Memorandum

SUBJECT: **REGULATING PLAN WITH MAJOR WARRANTS FOR A DRIV-THRU RESTAURANT**

BACKGROUND: This is a request for approval of a regulating plan (concept plan) with major warrants for the proposed development of a restaurant with a drive-thru. The 1.3-acre site is generally located on the north side of Stacy Road, west of Highway 5 and is zoned for the (CPDD) Commercial Planned Development District with the Urban Village Sub-district. Applicant: Karis Smith with Jones & Carter, representing Village FV LTD.

EXHIBIT A - REGULATING PLAN

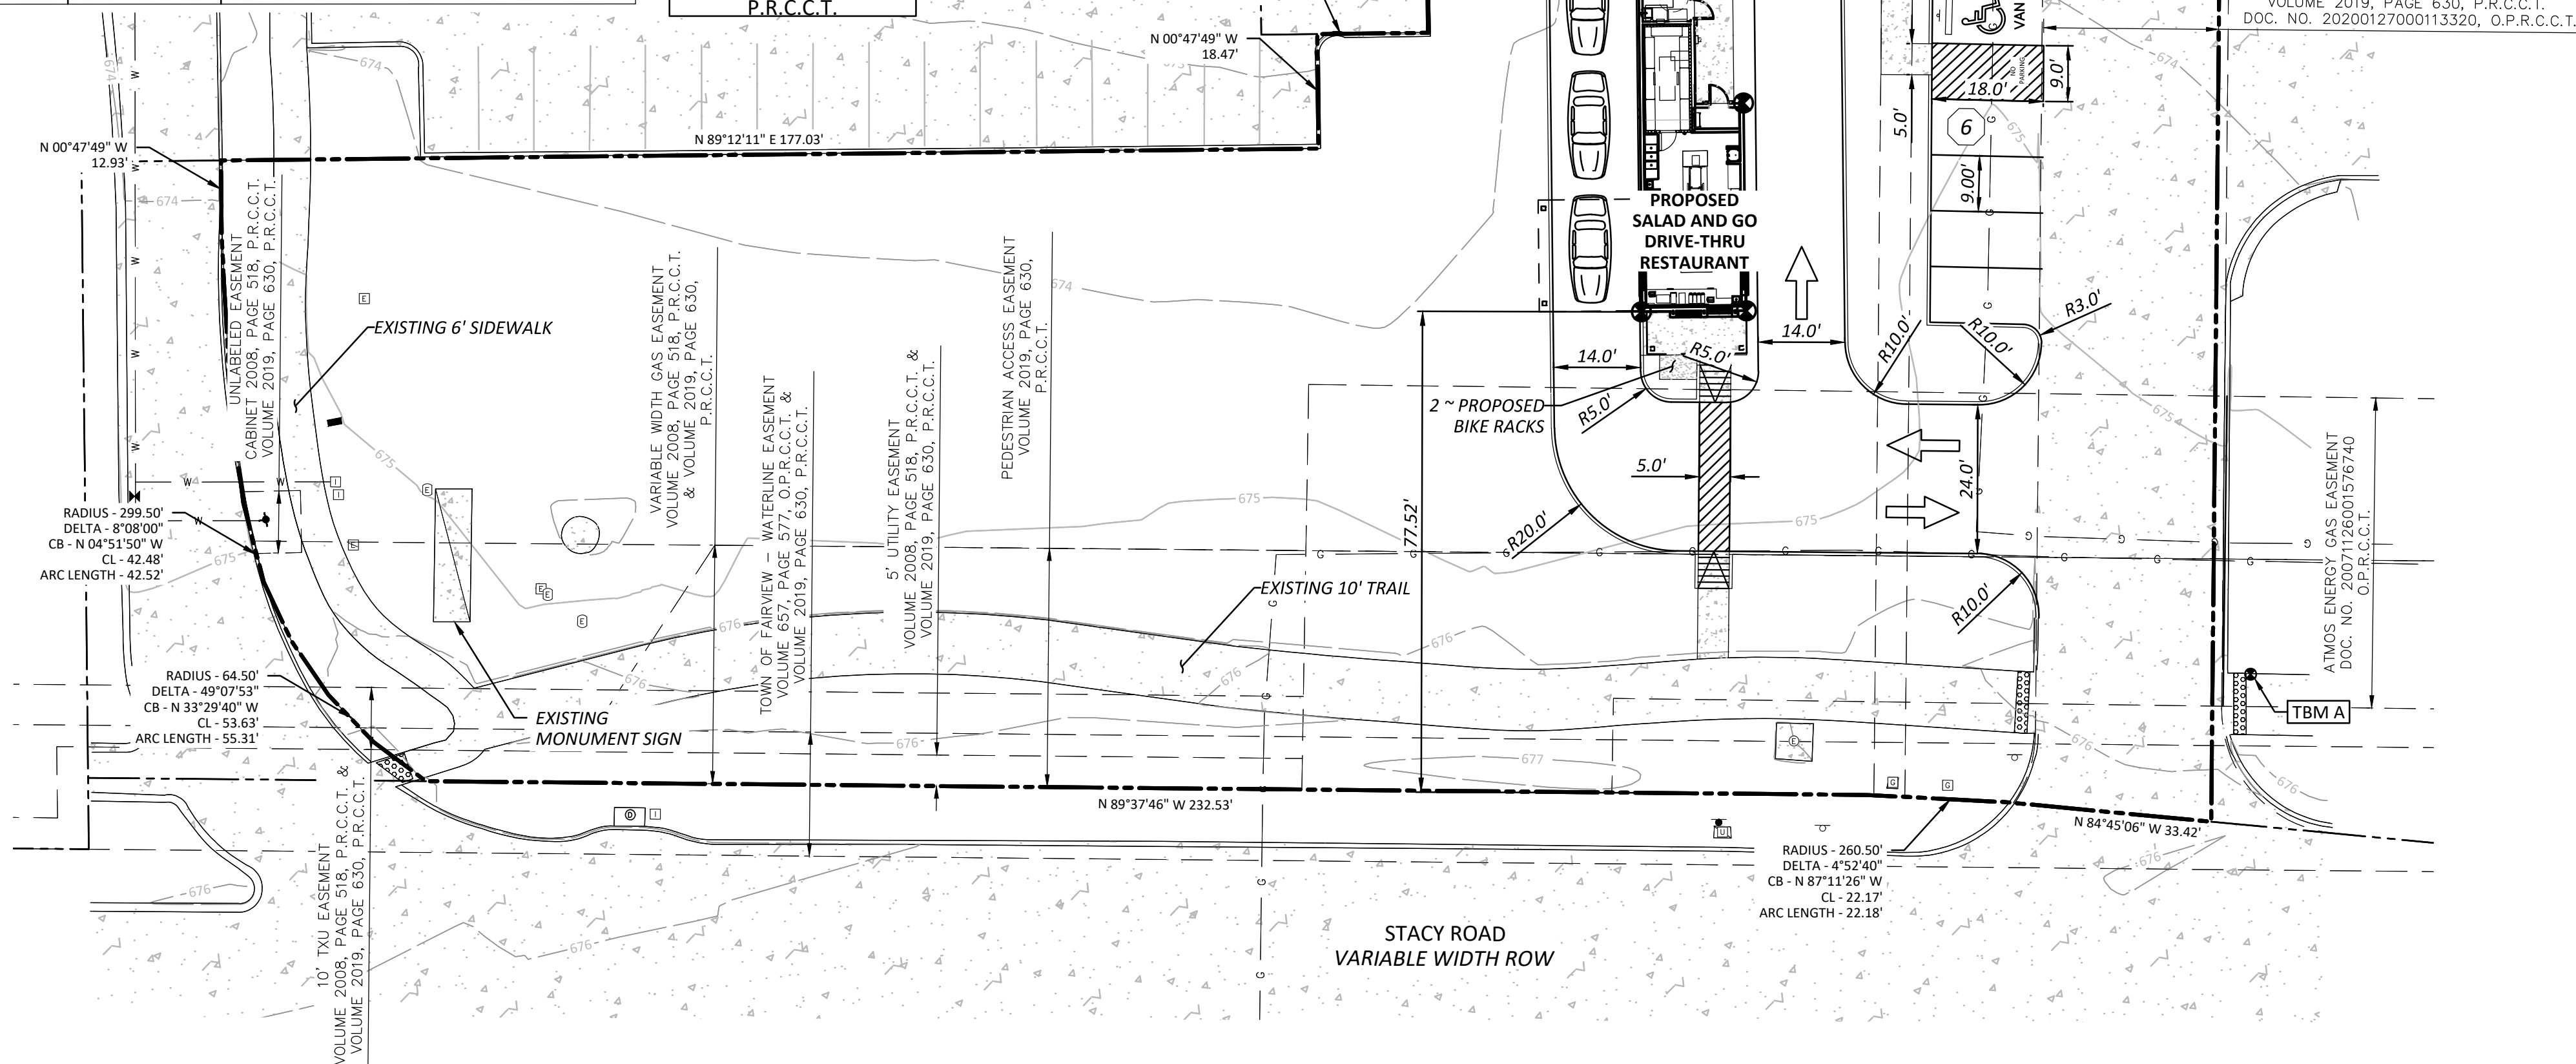
Item	Requirements	Proposed	Comments
	Use: Restaurant with a drive-thru	Major Warrant	Drive-thru	The CPDD requires that any restaurant with a drive-thru only be permitted upon the approval of a Major Warrant. In this case, the applicant is requesting the warrant in order to permit the development of a drive-thru soft drink facility.
	Main entry accessibility	Main entry adjacent to street	No public entrance	The structure has no interior customer space, and consists on only kitchen and staff areas, thus there is no public entrance.
	Site, Street, Block Face and Landscape standards	BTZ 18-26' with 80% frontage Street and street-scape design	77' setback from Stacy Road/185' from Southwind; 0% frontage As exists	Within the CPDD, typical standards would require that 80+% of a building façade be located within a build-to-zone, have dedicated streets with on-street parking and landscape islands. As with other new developments around the mall area, there are a number for existing site constraints that were previously constructed with the development of the mall area, that make it impossible to meet those criteria. In this case, Southwind Drive, is not a dedicated ROW. It is privately maintained access easement with existing utilities and infrastructure with no parallel parking. Along Stacy Road, a number of existing easements, utilities and design features approved with the original development of the mall, prevent the building from being able to meet the Build-to-Zone and frontage requirements, in addition to providing the necessary looped drive for the drive-thru use.

1. Site shall be development generally in accordance with the attached regulating plan exhibits
